SECTION 4

FAILURES OF STATUTORY COMPLIANCE

4.1 Introduction

Figure 4.84: Extract from Harley Drawing C1059-305-D 'Typical Joint Upper Levels' {HAR00008903}

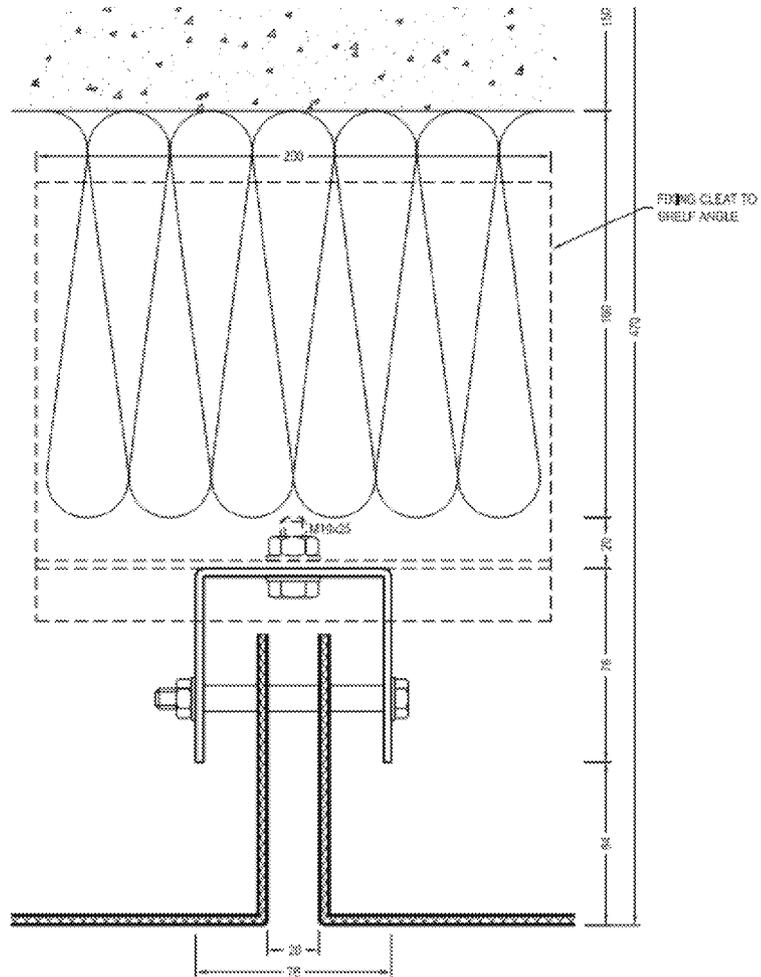
4.4.107 The Harley drawing below (drawing C1059-305-C) {HAR00009737} is a detail in plan showing the vertical channels that support the ACP cassette panels. It illustrates this point further. Whilst the SideRise horizontal cavity barriers can be cut fairly tight around the vertical rail support rail, it is inevitable that a gap is left at the point that the cassettes 'hook' over the support pin.

Figure 4.85: Diagram created on Harley Drawing C1059-305-D (Additional notes added in red) {HAR00008903}

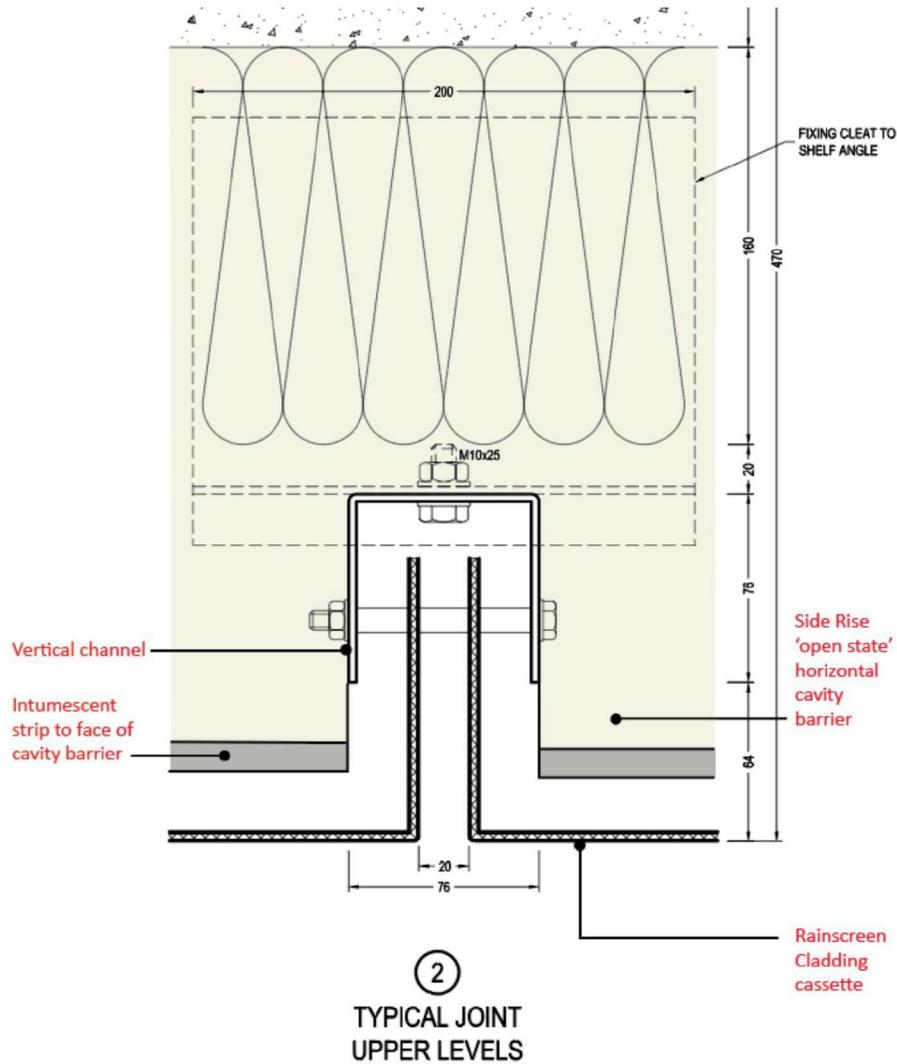
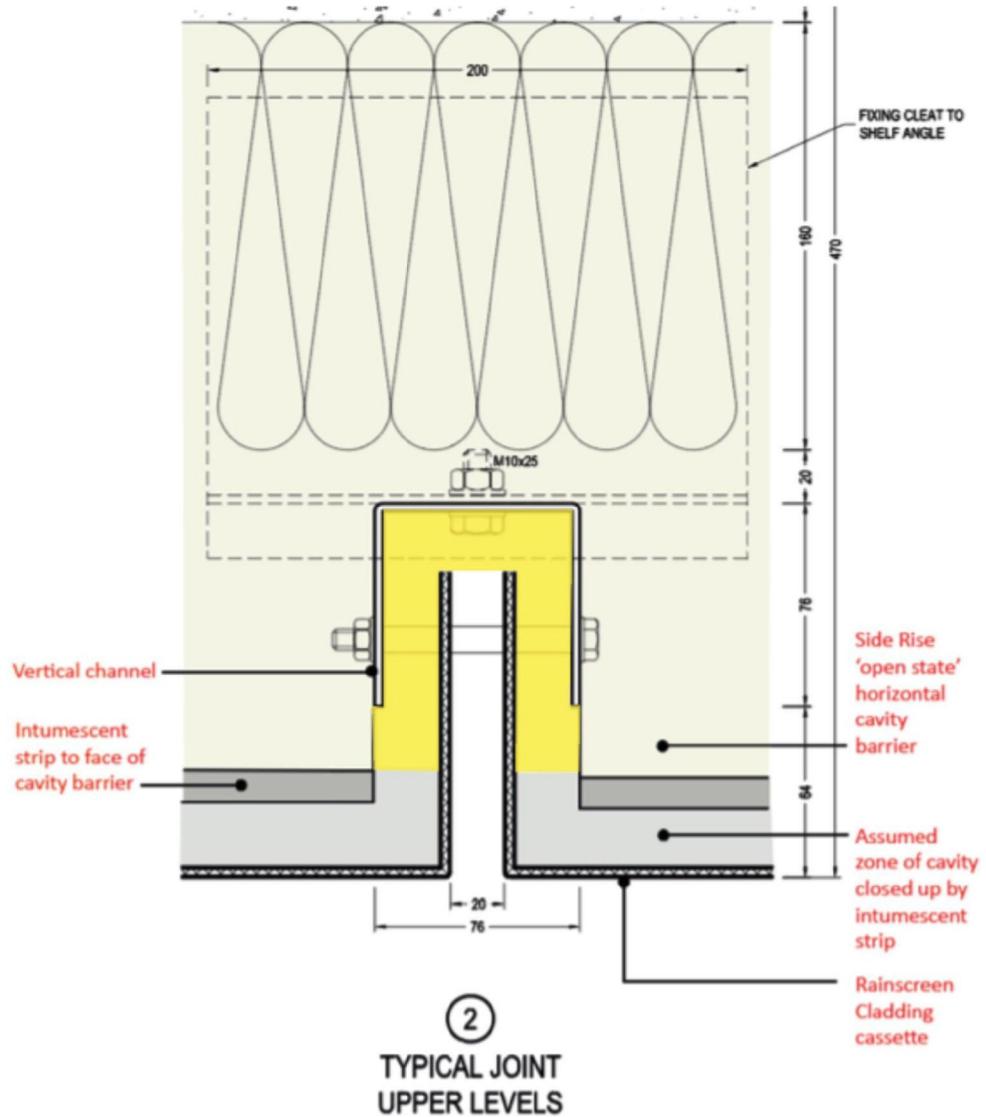
4.4.108 I have created two diagrams which I show below which further illustrate this point. They show the cavity barrier, respectively in normal mode and during fire with the intumescent strip expanded to the inside face of the ACP cassette. I have annotated the diagrams by shading in yellow the gap within the channel that provides a vertical path through which fire can bi-pass the cavity barrier and travel upwards, bi-passing the cavity barrier and entering into the 'compartment' above. This clearly demonstrates that the integrity of the cavity barrier at the joint is not maintained and requires further attention. I showed how this issue might be addressed within Section 3 as part of my indicative approach.

Figure 4.93: Diagram produced using Harley Drawing C1059-200-I {HAR00008581} and Studio drawing 1279 (04) 105 ‘Proposed Residential Plan’ {SEA00010474}

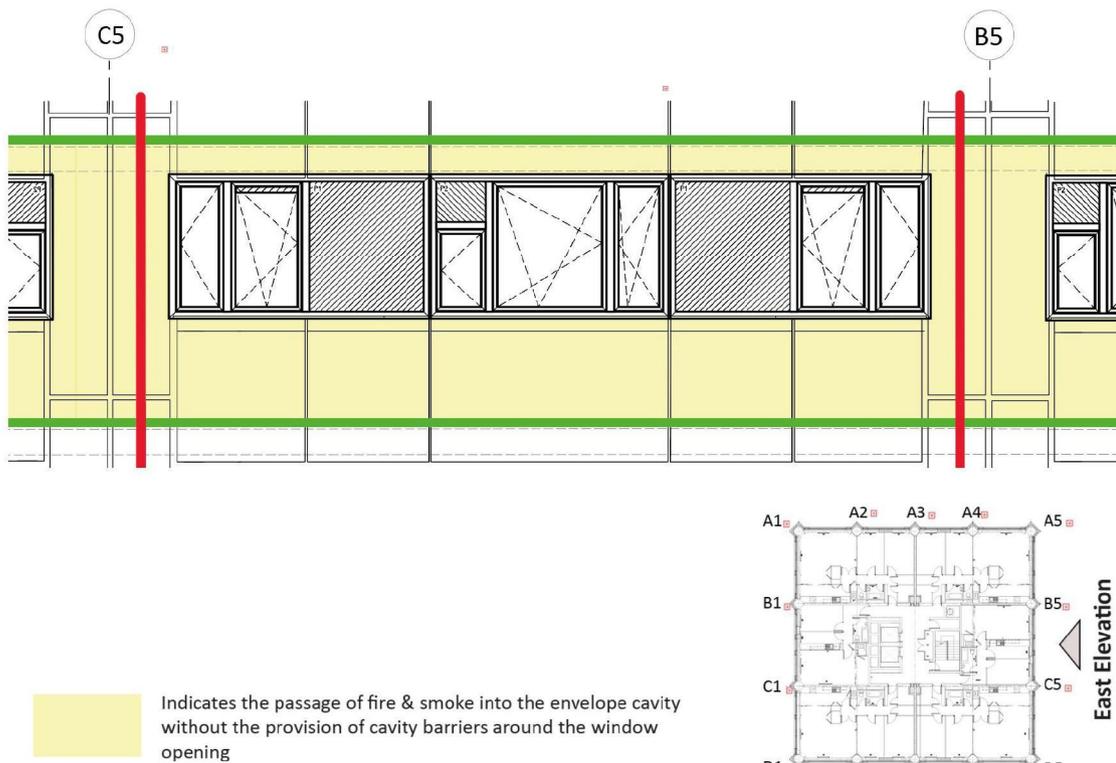
4.4.133 The marked up Harley drawing can be usefully read with Dr Lane’s report and diagrams, wherein she shows the weaknesses in the arrangements that facilitated the passage of fire within the inner reveal areas of the windows at head sill and jamb positions and thereafter on out into the cavities. For example see her Figures: 9.11, 9.12, 9.14, 9.15 and 9.16 {BLAS0000009}. My mark-up below essentially shows what I believe are the weaknesses in the Studio E/Harley design expressed in elevational form.

4.4.134 As the marked up drawings below demonstrate, once within a cavity zone – any cavity zone - the fire could move freely vertically up the sides of windows within that cavity zone and within the adjoining column zones – particularly at the open joint at the ‘nose’ of the column and within the ‘grooves’ to the concrete columns that ran vertically to the columns, thus bi-passing the horizontal barriers at each floor level. (Dr Lane has covered this in great detail within sections 9 and 10 of her report). In this respect construction / installation errors are always a risk in building work but these fundamental errors in design meant that the Harley construction documentation, which Studio E endorsed, was deeply flawed in concept.

Figure 4.98: Extract from Harley drawing C1059-301-D indicating 'insulation by others' {HAR00008470}

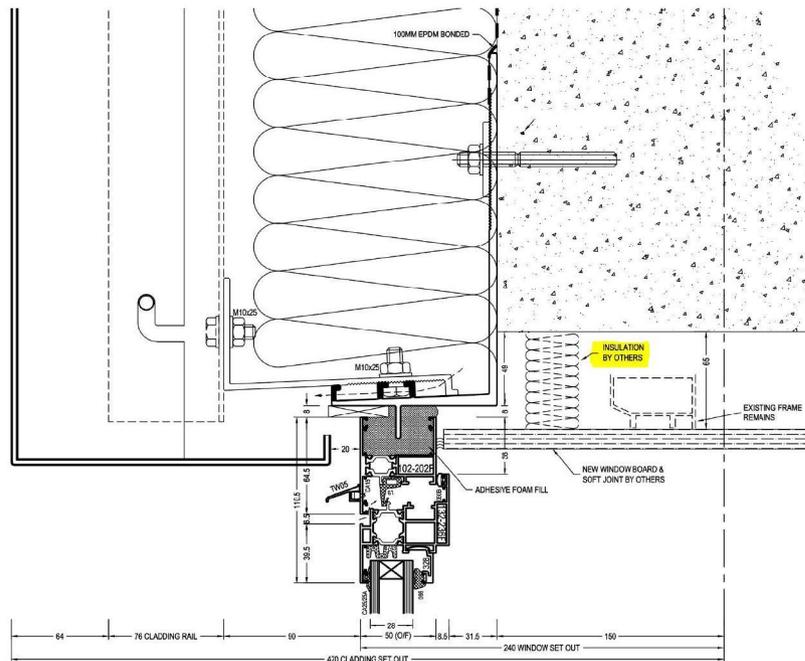
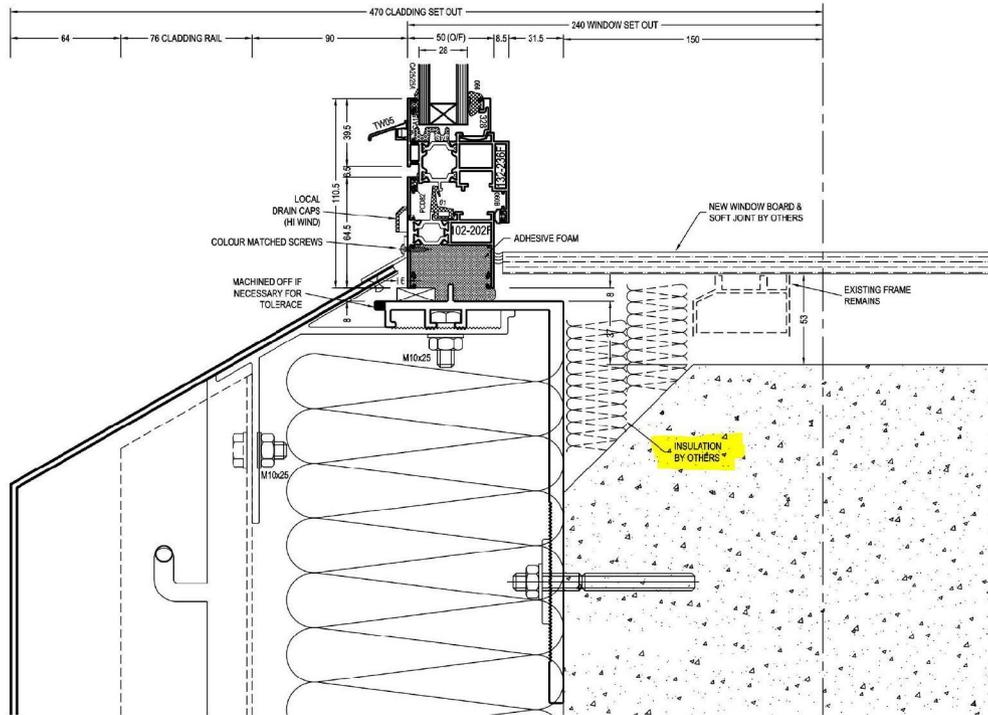
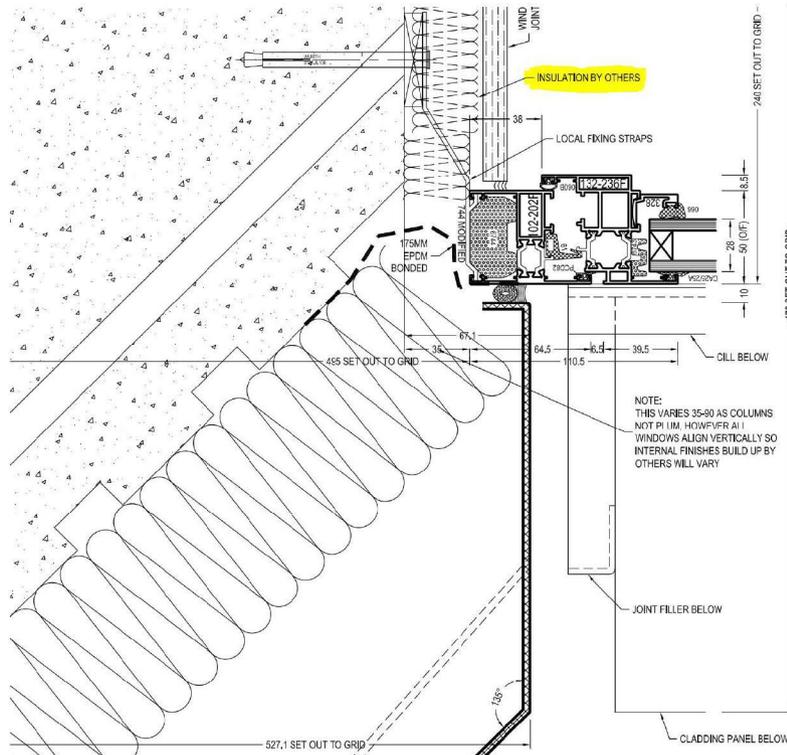
4.4.143 The Harley drawings that were issued as 'Approved for Construction' following checking by Studio E) (for example C1059-300-E, C1059-301-D, & C1059-302-D as exhibited below) {HAR00008469} {HAR00008470} and {HAR00008880} indicate that the insulation to the head, jamb and sill behind the window reveal linings were to be supplied and installed 'by others' ({HAR00008469}, {HAR00008470} & {HAR00008880}).

Figure: 4.106 Extract from Studio E drawing 1279 (06) 120 'Detail Section Sheet 1' {SEA00003436}
 (NB: The extract is from the drawing above but the envelope below the residential area - there is no other reference to the insulation type on the section)

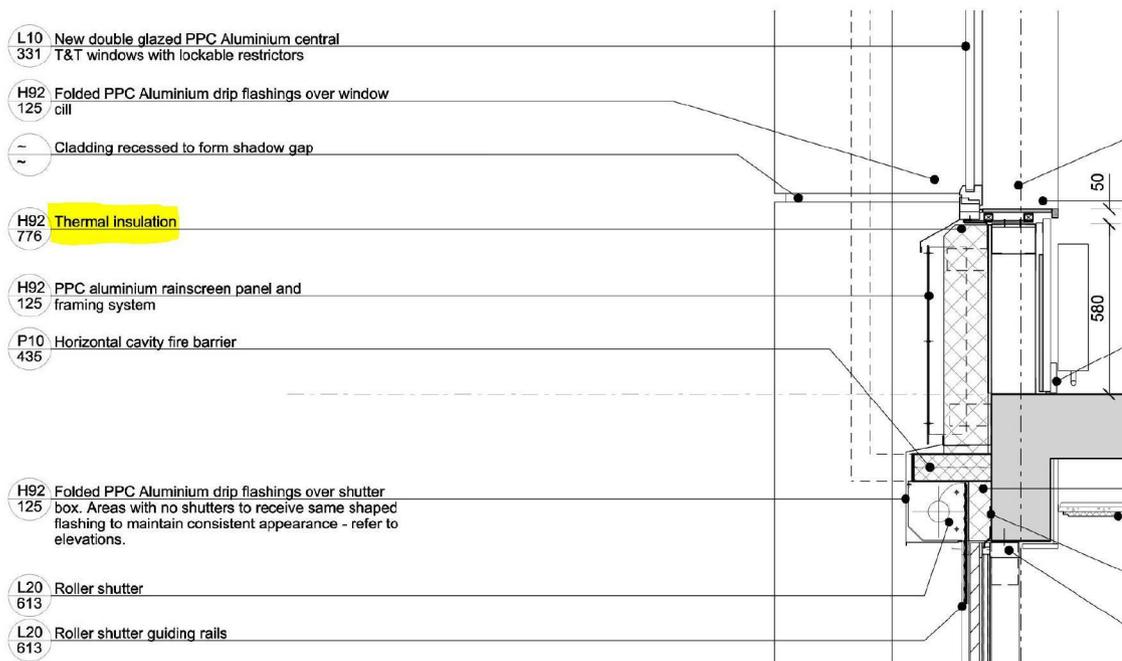
- 4.5.6 The exhibit below {SEA00003436} shows one of Studio E's 'As Built' drawings: Section 1279 (06) 120 00. Whilst it does not include any reference to the insulation type that was incorporated within the envelope construction, the highlighted note indicates 'Thermal Insulation H92/776'. This is a reference to an NBS Specification sheet. However, the completed NBS specification sheet appears not to have been issued as part of the 'As Built' set {RYD00000435}.

Figure: 4.107 Extract from Studio E drawing 1279 (06) 120 'Detail Section Sheet 1' at the Crown {SEA00003436}

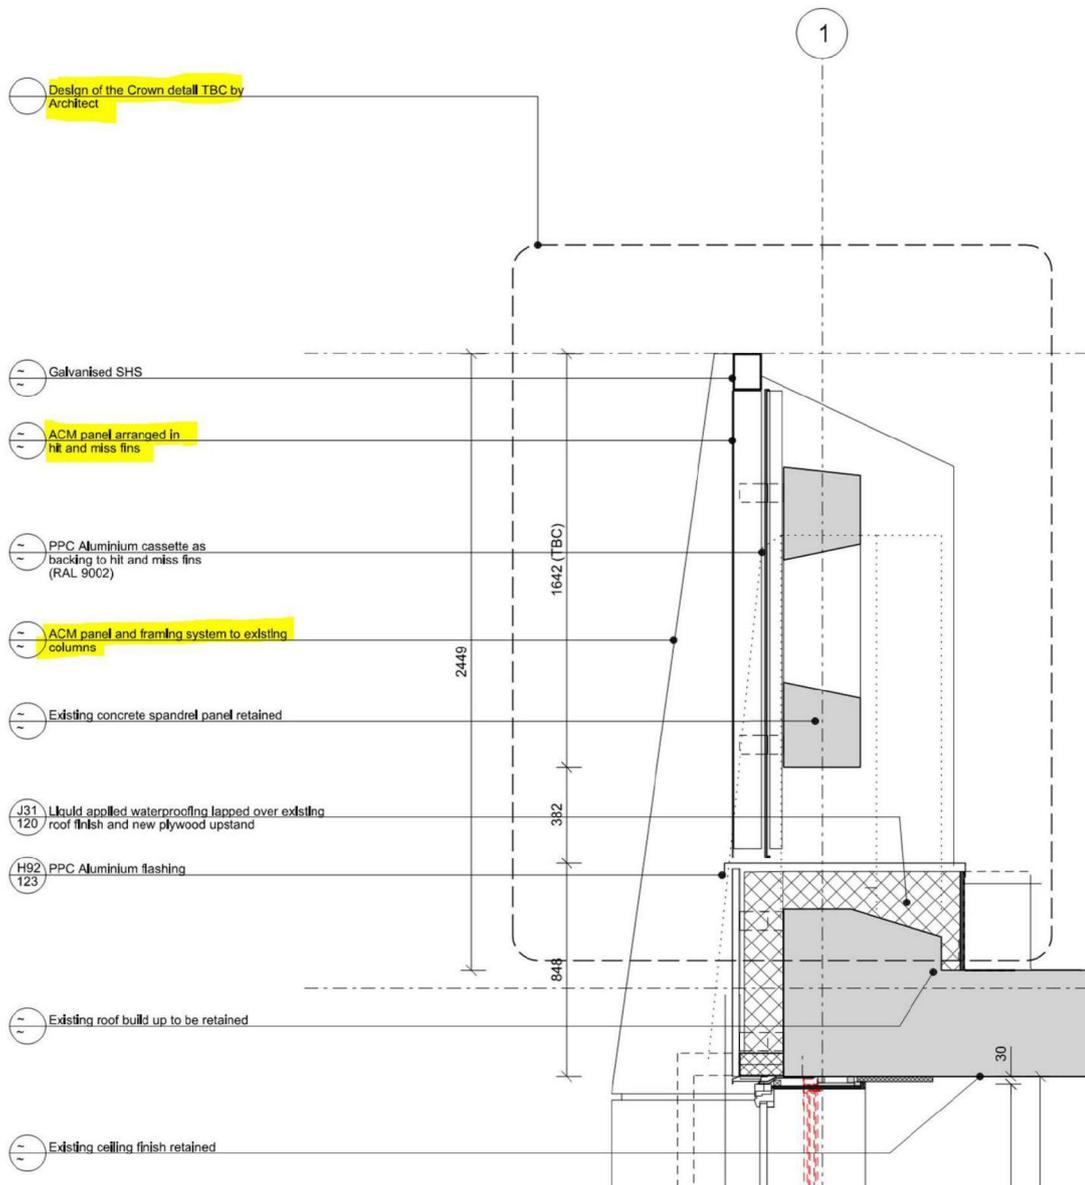
4.5.11 Studio E's 'As Built' record drawings show a combination of ACP and Zinc Rainscreen cladding – the main facades are mostly zinc but reference is made to ACP at the Crown. The two exhibits below illustrate this. This is clearly wrong as the building was clad in ACP.

Figure: 4.110 Extract from Studio E drawing 1279 (06) 120 'Detail Section Sheet 1' with Vertical and Horizontal Cavity Barrier Highlighted {SEA00003436}
(Additional note added in red)

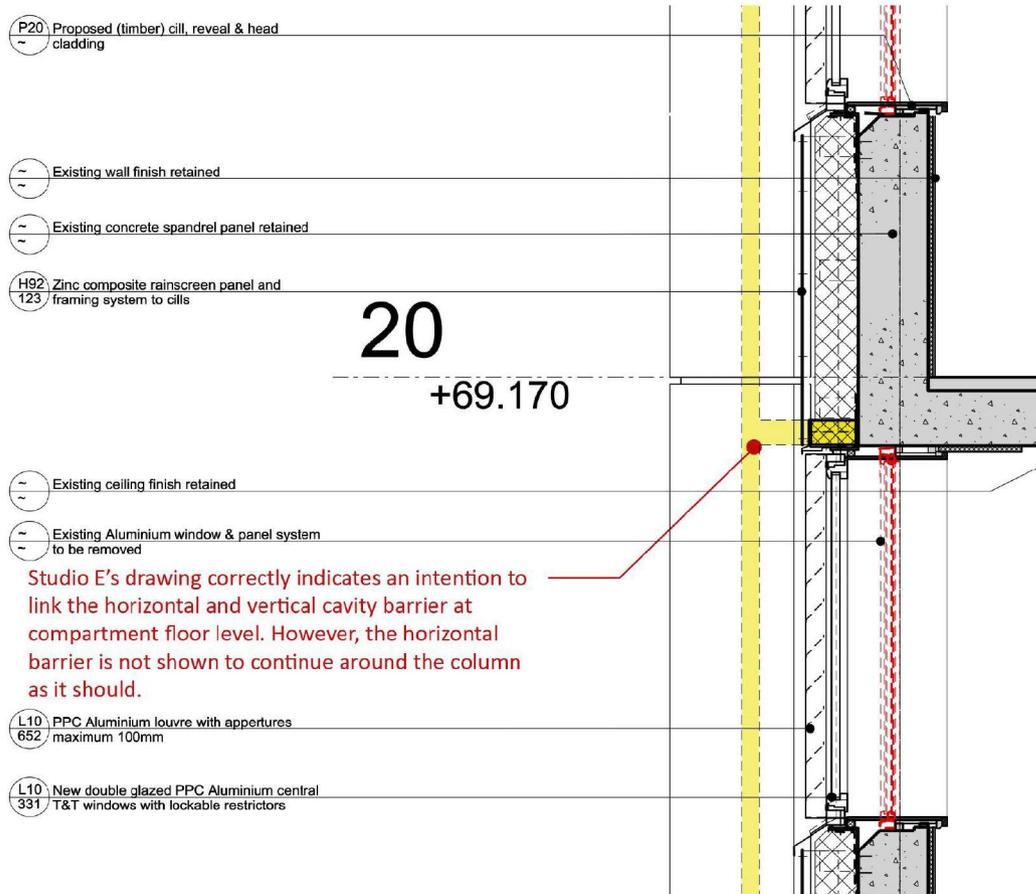
4.5.14 Studio E's 'As Built' drawing 1279 (06) 120 - 00 'Detail Section Sheet 1' {SEA00003436} shown below indicates cavity barriers to the line of the compartment floor and the head of the window only, as annotated on the exhibit below. The cavity barrier at the head (no specification note) could function as both a cavity barrier to the window head and the compartment floor alignment if agreed with the Fire Engineer and the Building Control Officer. However, the 'As-Built' drawings show the cavity barrier over the window in a position that is inconsistent with the Harley drawings (Figure 4.83), and it seems with the position as installed. There is no cavity barrier indicated to the window sill which, although apparently correct as a record of the as-built condition, represents a failure to meet the recommendations of ADB2.

Figure: 4.118 Extract from drawing 1279 (06) 120 'Detail Section Sheet 1' {SEA00003436}

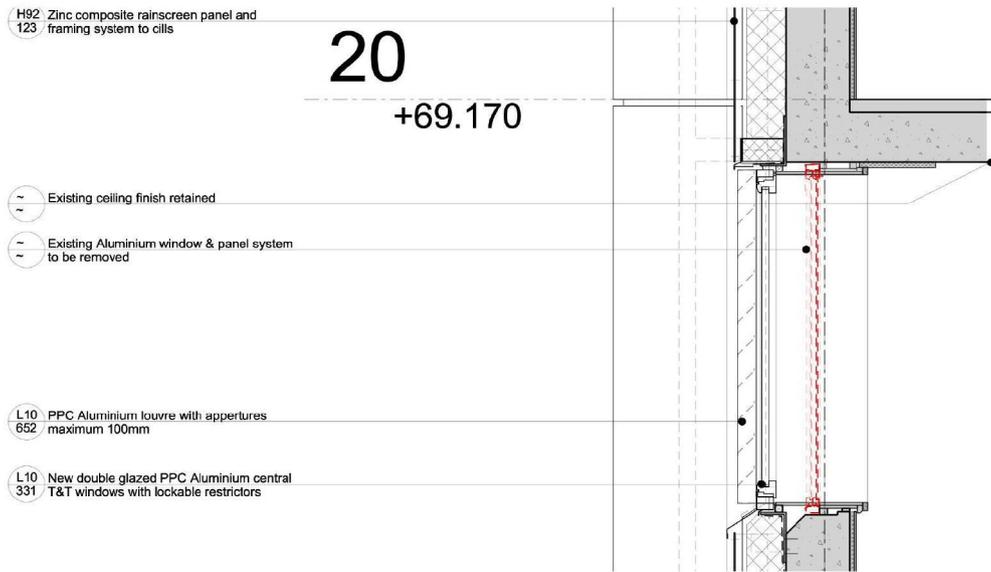
4.5.23 Studio E's 'As Built' drawing 1279 (06) 120 00 'Detail Section Sheet 1' does not (as shown below) indicate any packing material to the window head or sill {SEA00003436}.

Figure: 4.121 Photos taken by HKS at Grenfell Tower on 15 May 2019

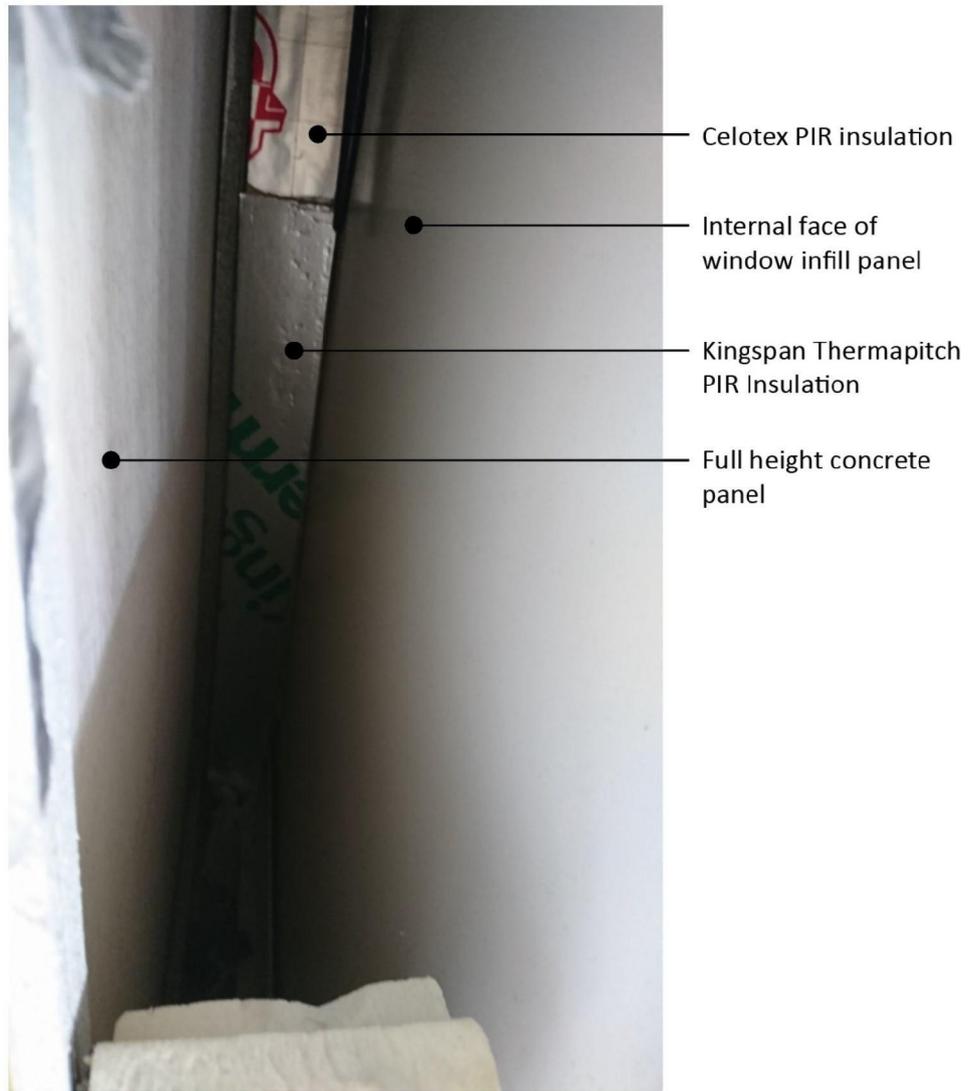
4.5.25 An example of the window panel on Level 4 (looking horizontally from a window reveal into the cavity) suggests that between the existing concrete infill inside face the gaps behind the window reveal lining boards have been closed with offcuts of Kingspan Thermapitch and the Celotex. As stated earlier herein, neither product would meet the requirements of ADM Clause 12.7 for insulation to be of limited combustibility.
